**Re: Flatiron Meadows Planning Area C Preliminary Plat, Amendment No. 2
Comment Response Letter**

**FLATIRON MEADOWS – PLANNING AREA C
PRELIMINARY PLAT REVIEW RESPONSE**

FLATIRON MEADOWS PRELIMINARY PLAT, AMENDMENT NO. 2

Sheet	11 of 13
Date	JANUARY 27, 2017

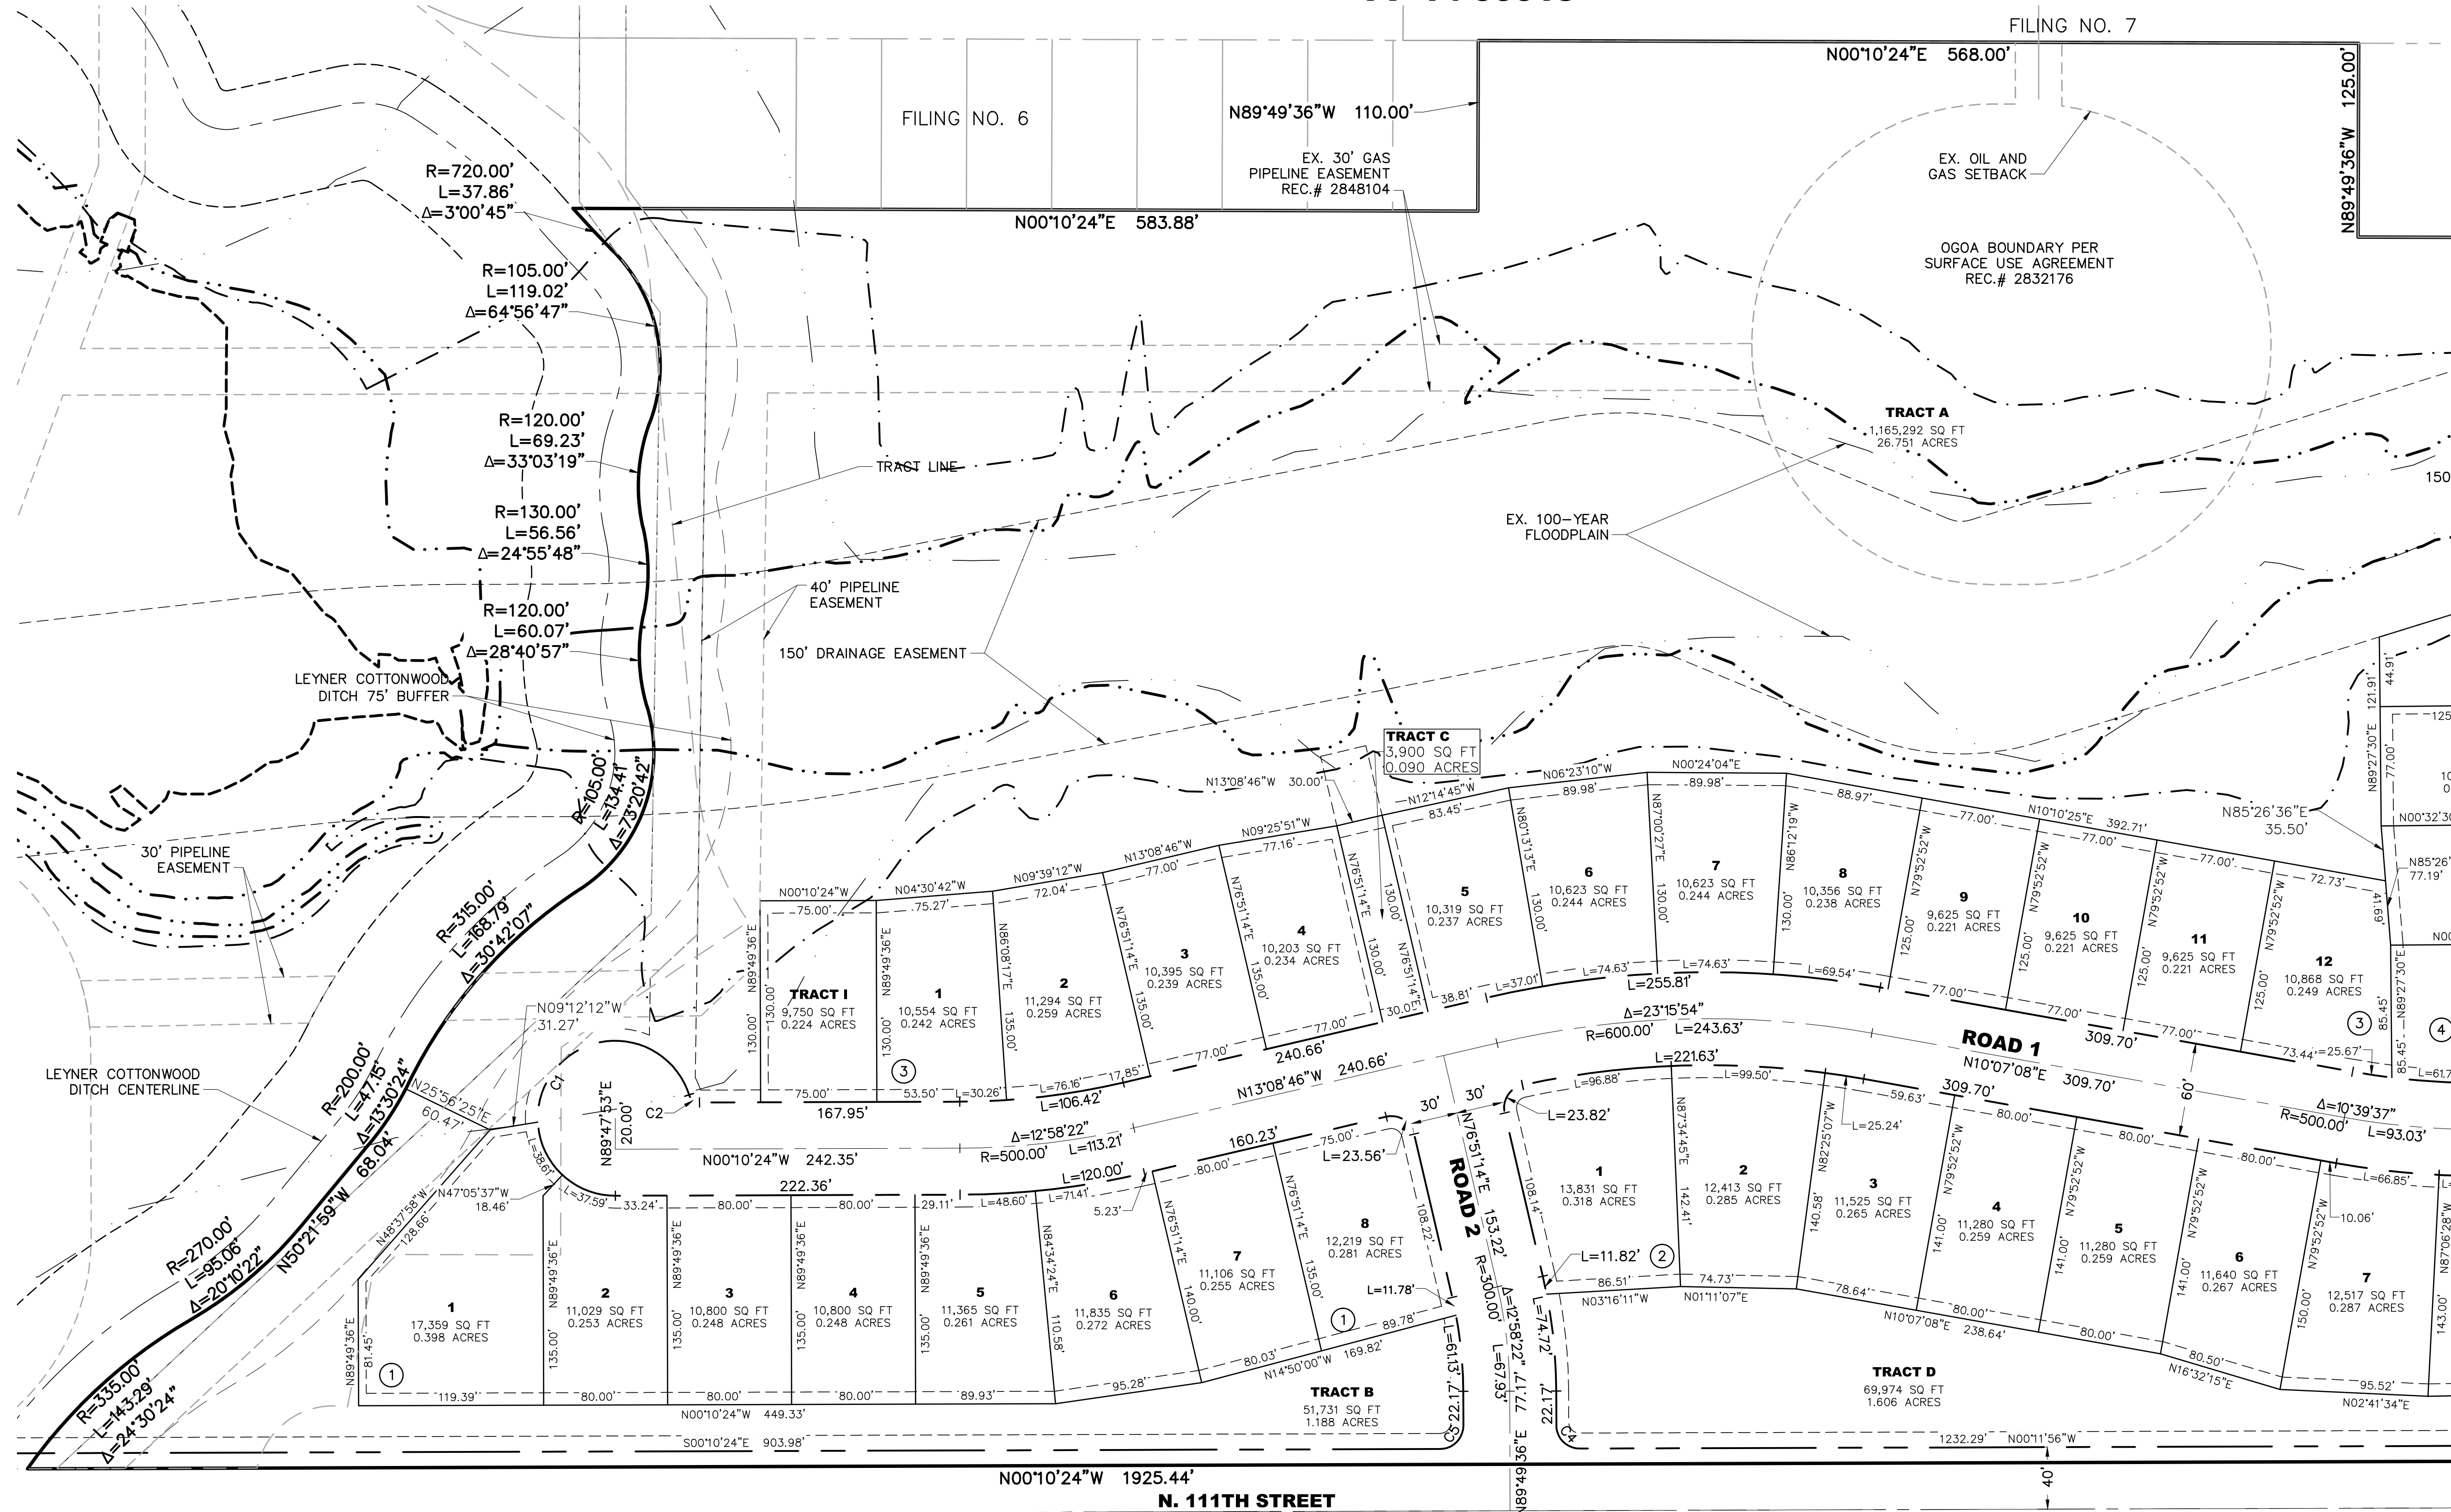
8. Sheet SP1 – Site Plan 1
 - a. The grayscaled line on this sheet shows the limits of the Lots and Open Space from the approved Preliminary Plat No. 1 for comparison. Lot 5, Block 8 encroaches too far past the previous plat limits and further narrows the narrowest portion of the open space corridor. Delete Lot 5 or adjust to the south and west to match previous preliminary plat. Please delete

Response: This row of lots has been adjusted to minimum lot sizes and the knuckle has been removed to gain open space east of lot 5.
 - b. Tract E is called out as the Pocket Park. It extends out into the flood plain, dam breach, and drainage easement limits. Adjust boundaries of Tract E to be located outside of the 150' drainage easement limits.

Response: The boundary of Tract E has been adjusted to be outside of the drainage easement.
9. Sheets SP2 & SP3 – Site Plan 2 & 3
 - a. Lot 1, Block 1 is a flag lot and prohibited by the UDC. The lot must meet the minimum lot width requirements (80') at the front setback line (25' into the lot). Lot 1 doesn't achieve its minimum 80' width until ~120' into the lot from the cul-de-sac ROW. You may be able to adjust the bulb/curvature of the cul-de-sac to increase the street frontage of Lot 1 and as a result the setback line is in the wider portion of the lot. You also may be able to modify the side lots lines of Lots 2-5 to gain some width for Lot 1.
